1-11 olive street, SEVEN HILLS

Location of non-complying balconies and recommended design changes

Compliance with the Apartment Design Guide (ADG)

FIRST 4 STOREYS

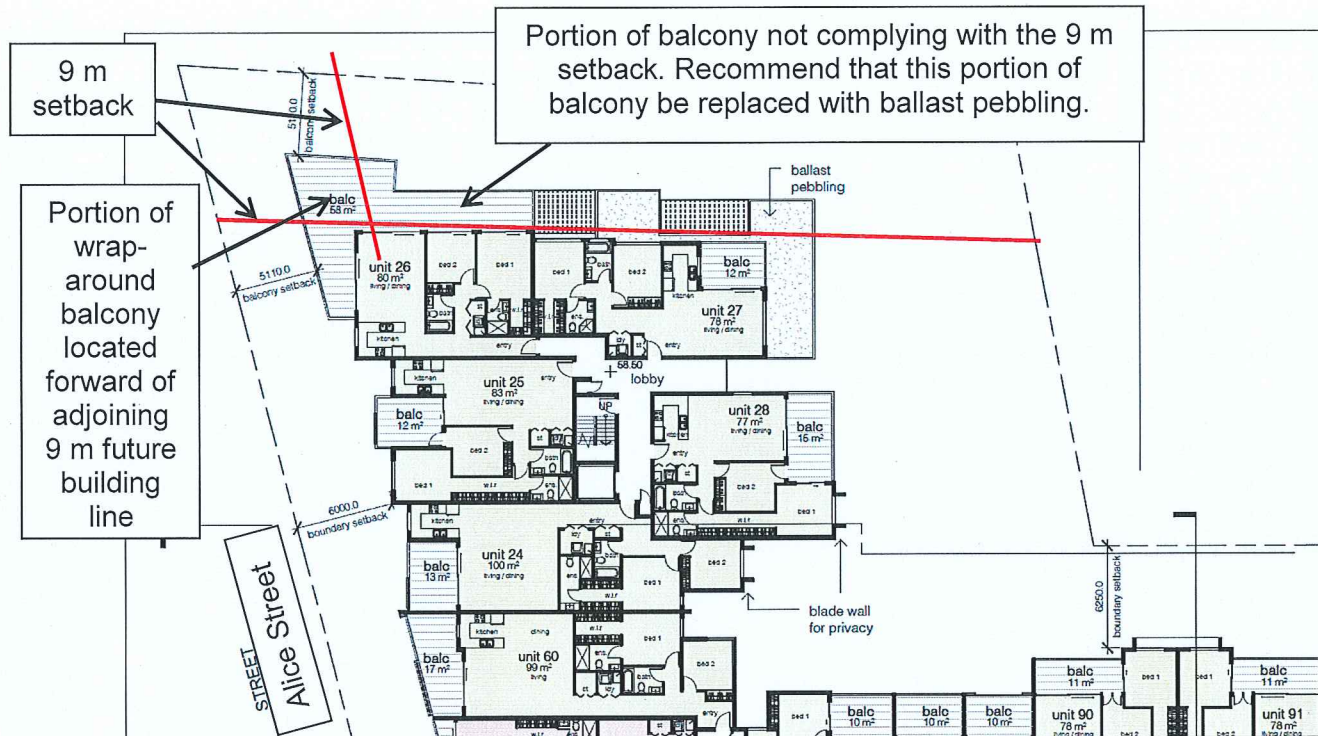
Under the Apartment Design Guide (ADG), the minimum side setback requirement to the balconies is 6 m for the first 4 storeys. At the first 4 levels the balconies are setback 5 m in accordance with Council's DCP. The 1 m encroachments are considered minor and subject to suitable privacy screens being provided, it is considered that there will be no impact on neighbouring properties. The small encroachments are shown above.

LEVEL 5

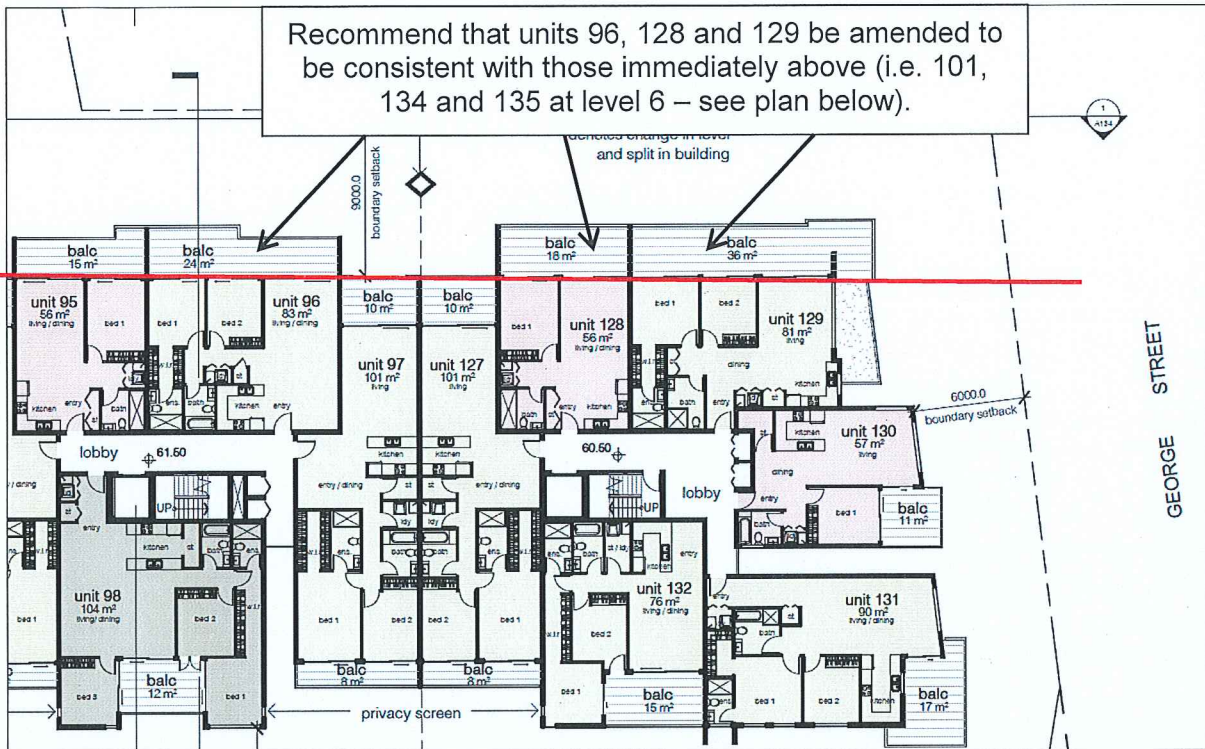
Under the Apartment Design Guide (ADG), the minimum side setback requirement to the balconies is 9 m for the upper 2 storeys of this development. While the 6th level complies with the 9 m setback requirement, some of the balconies at the 5th level do not comply. It is recommended that a portion of the wrap-around balcony on the north-east corner of the building, be replaced with ballast pebbling similar to the adjoining units.

LEVEL 5

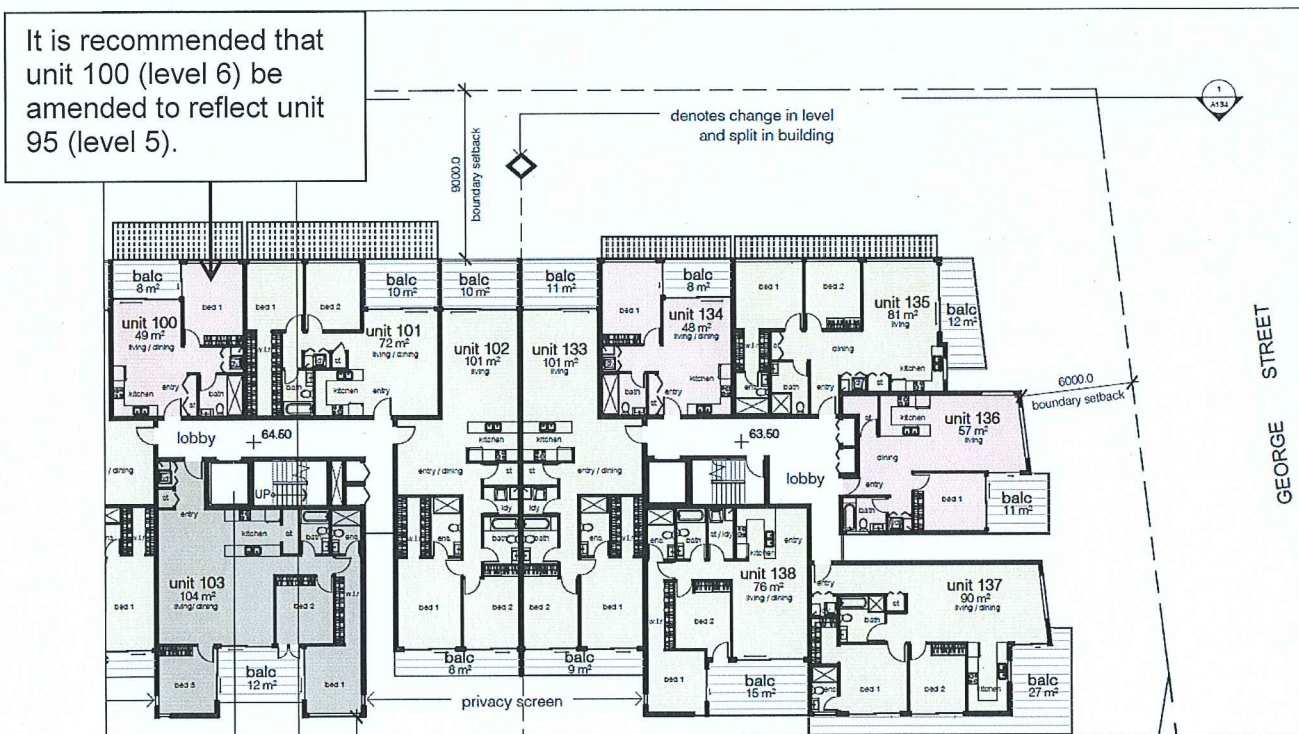
While the 6th level complies with the 9 m setback requirement, some of the balconies at the 5th level do not comply. It is recommended that the 3 non-complying units be amended to be consistent with the corresponding unit at level 6.

LEVEL 6

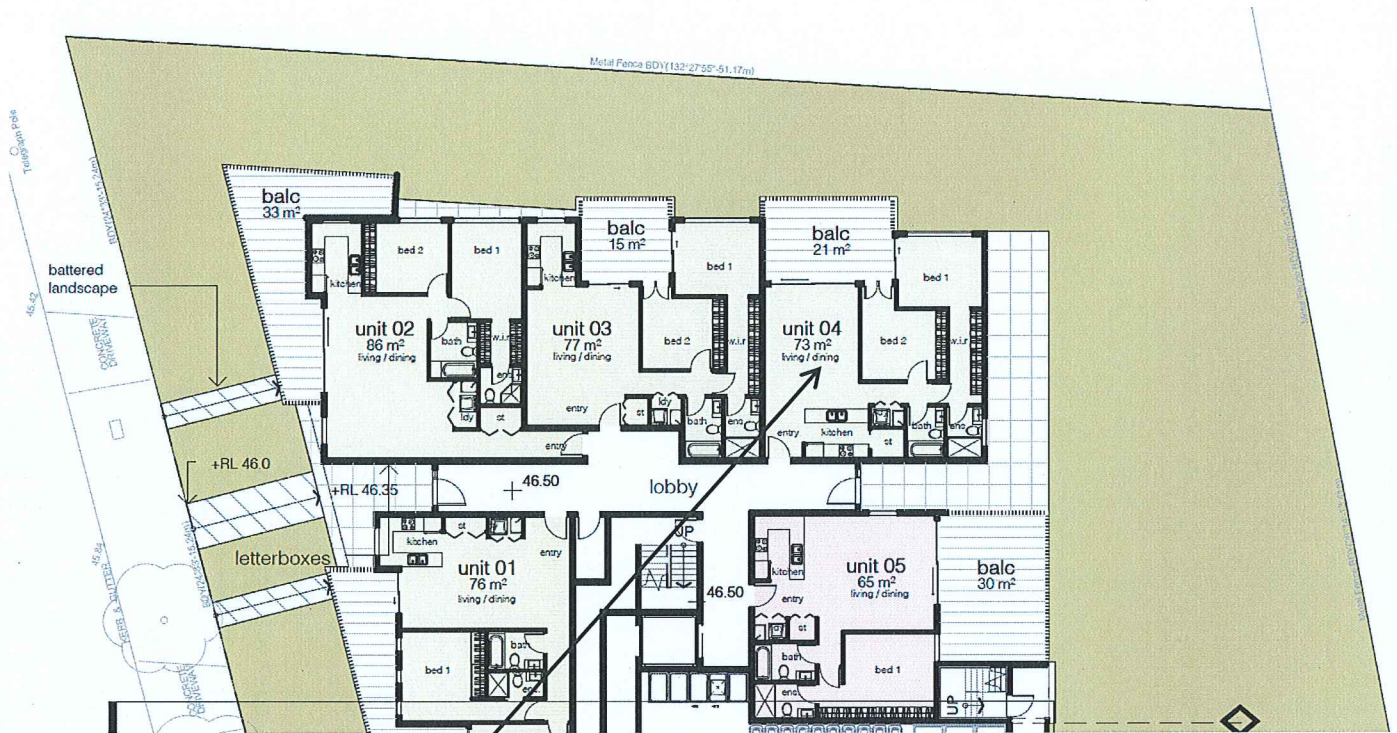
The units at the 6th level comply with the 9 m setback requirement.

It is recommended that unit 4 (and units 10, 16 and 22 immediately above) be amended to provide a minimum floor area of 75 sqm.

The ADG requires that any 2 bedroom unit containing 2 bathrooms must have a minimum floor area of 75 sqm. To ensure strict compliance with this requirement, it is recommended that units 4, 10, 16 and 22 be increased in area from 73 sqm to 75 sqm. Given that the balconies for each of these units well exceed the minimum requirements, a minor amendment can easily be achieved.
